FIELD INSPECTION

Project Name:	Mountain Valley Pipeline	Inspector:	Matthew Grant
Inspection Date:	Tuesday, May 14, 2019	Project Contact:	Brian Clauto
Spread: Pittsylvania County MP296-298 St15650-15739	Spread I	Weather (Wet/Dry/Rain):	Dry

FIELD INSPECTION PHOTO LOG

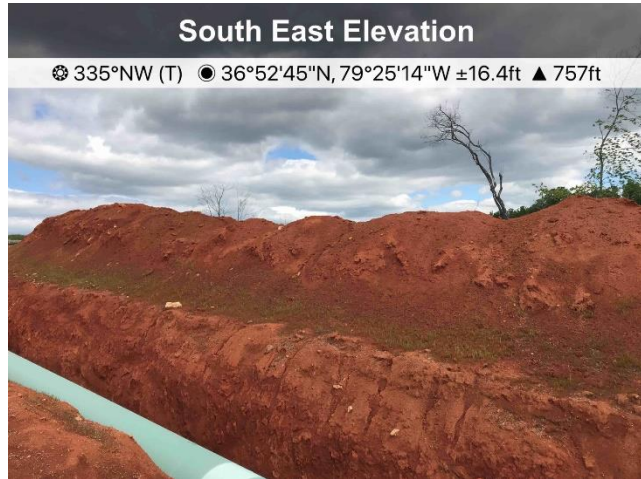
- Streams / wetlands inspected included: S-Q4, W-Q2, S-Q3, S-Q2, SB-6, SB-8, SB-9. ECD's were in place at all inspected streams and no impacts were observed.
- St#15699- Soil stockpile lacks adequate stabilization
- Designated stream SB-8 remove accumulated sediment from bridge approach and repair undermined CFS

Recommended Corrective Action: Maintain all controls per the approved plan and specs.
